# Metropolitan Development Commission Regional Center Hearing Examiner (September 10, 2026) Meeting Agenda

2.    **2026-REG-044 | 2955 North Meridian Street**  
Center Township, zoned C-S (RC) (TOD) CD# 12  
Stock Yards Back and Trust Co., by Megan Short

## STAFF REPORT

| <b>Case Number</b>       | 2026-REG-006                                                                                                                                                                                                                                                                                                                                          |

**SD1.101**

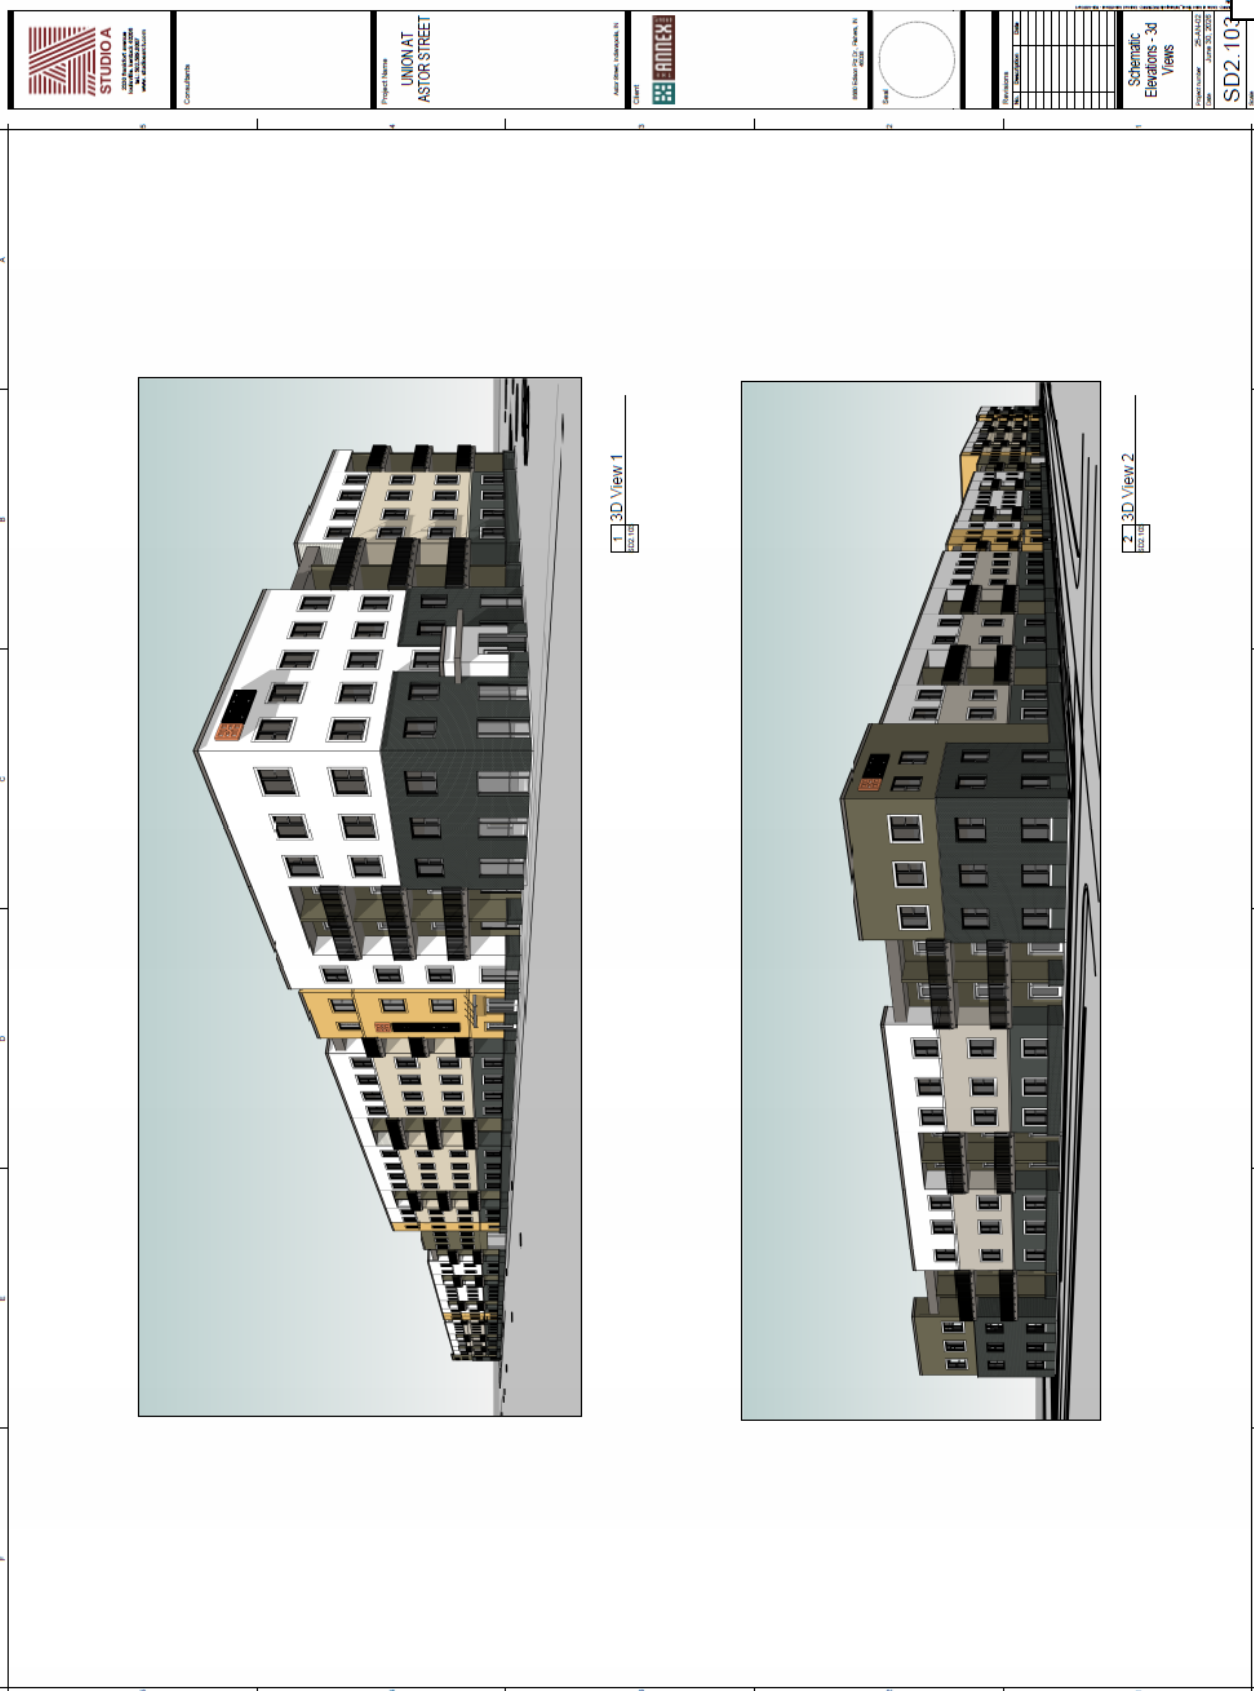
2. The building materials is primarily made of fiber cement, a man-made material. Staff requested additional natural building material. Subsequent revised elevations note added areas of brick on the façade. Guideline CA 2.2.1 applies.

#### August 14<sup>th</sup>, 2026, Design –

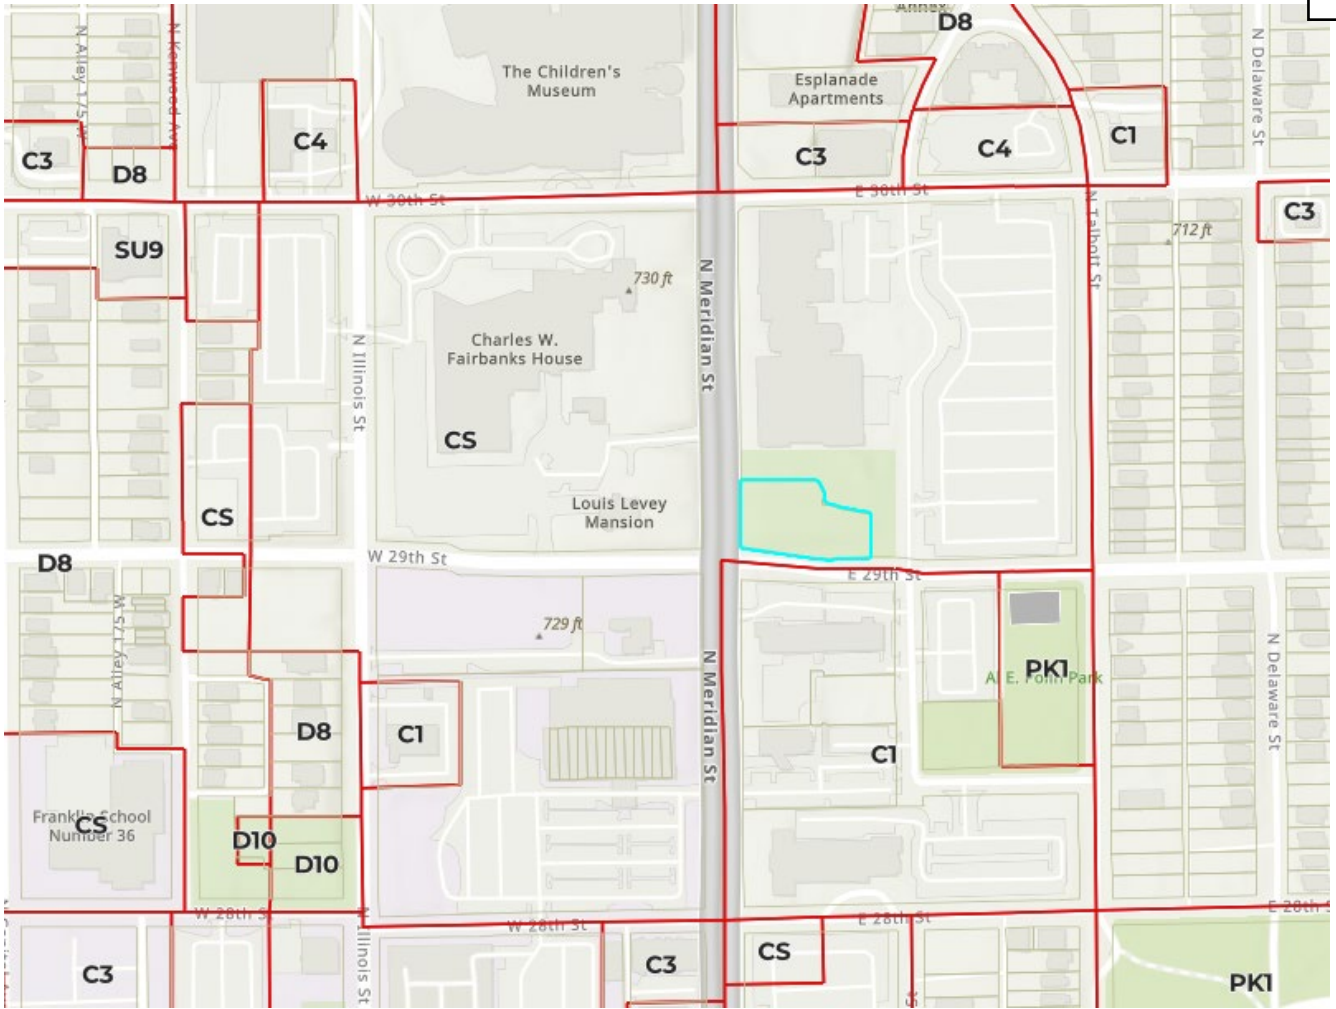
In the August 14, 2026, design, the building was moved outside of the clear sight triangle requirements, and transparency along the 29<sup>th</sup> Street elevation was improved. The scuppers located on the elevation fronting Meridian Street were also removed. Additionally, screening was added for the mechanical equipment along Meridian Street.

Site Plan – filed on September 4<sup>th</sup>, 2026

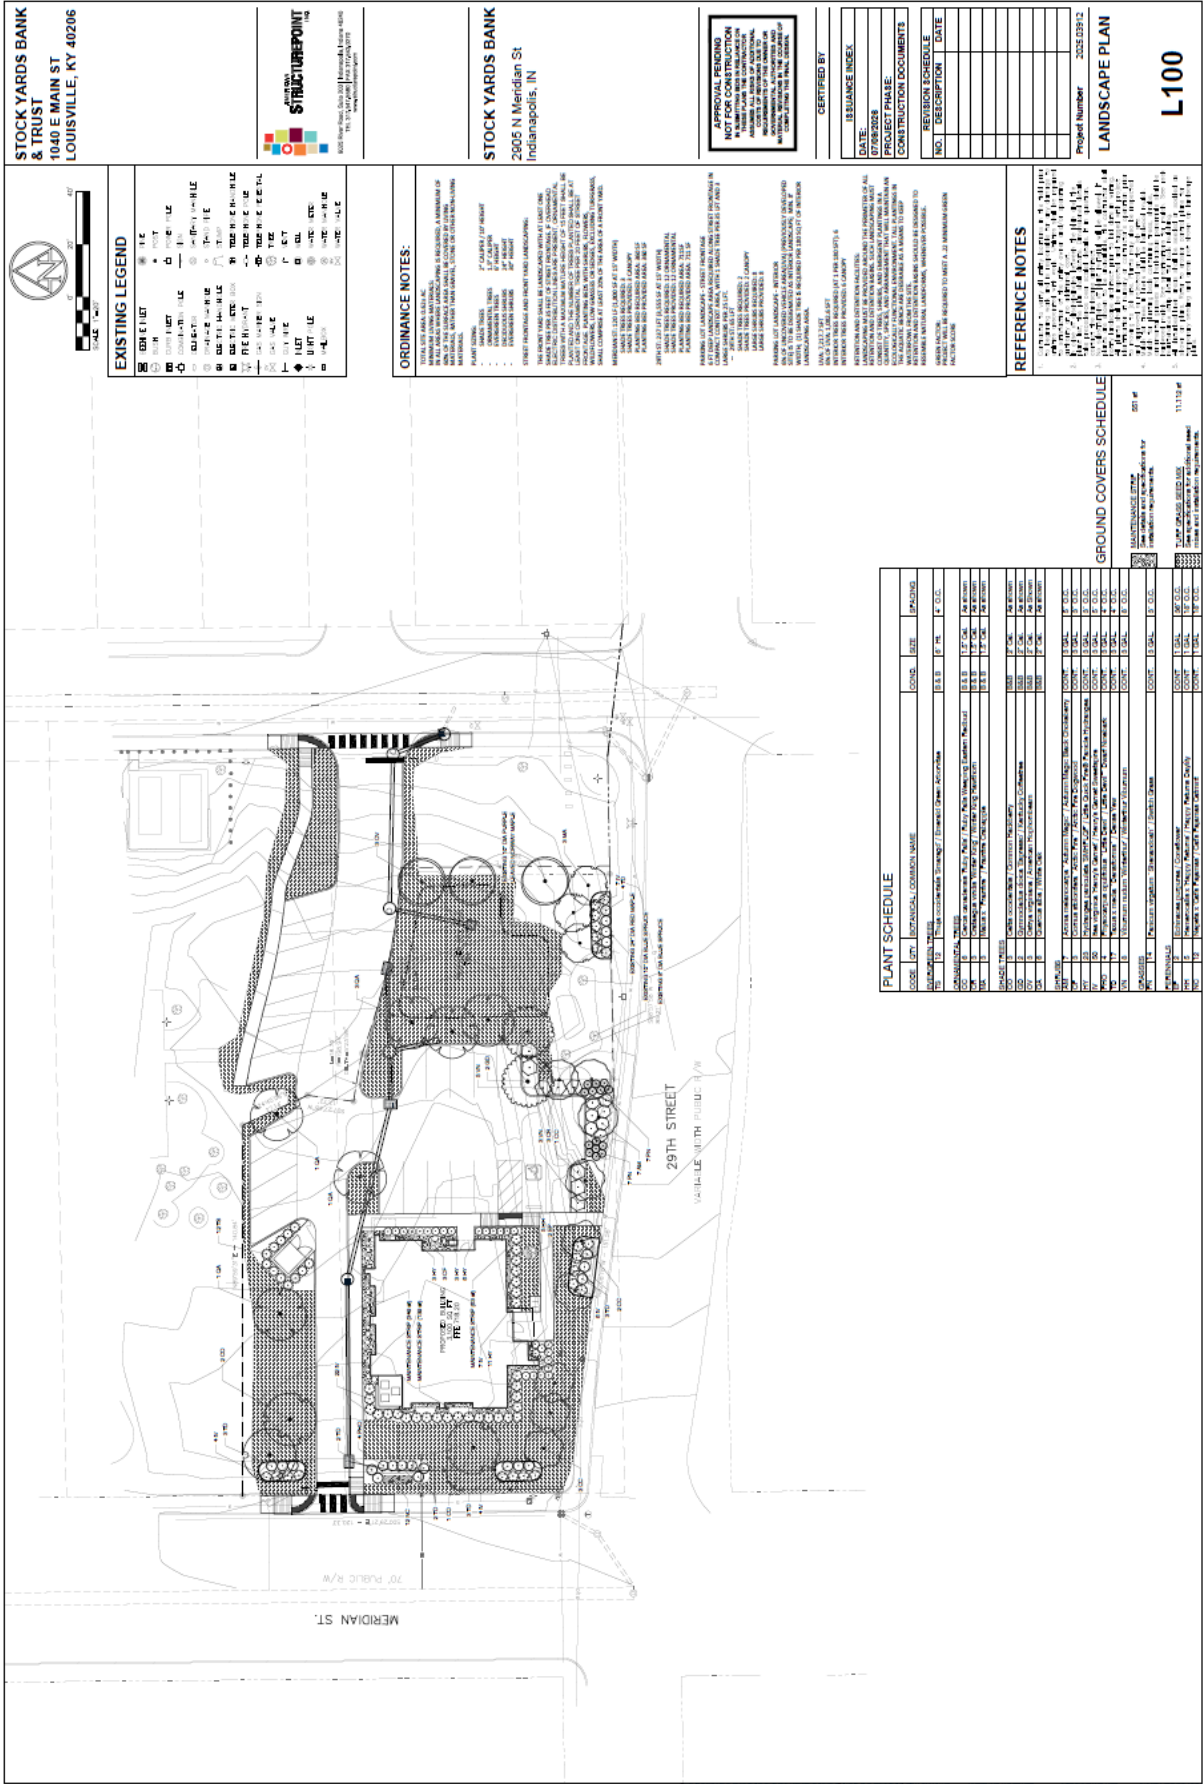
In the September 4, 2026, slightly revised site plan, the Meridian Street vehicle access point was changed to show that the curb and sidewalk would be angled to intentionally require vehicles to exit the site to the right, or north-bound Meridian Street and discourage entering the site from Meridian Street. This will encourage access to the site from 29<sup>th</sup> Street.
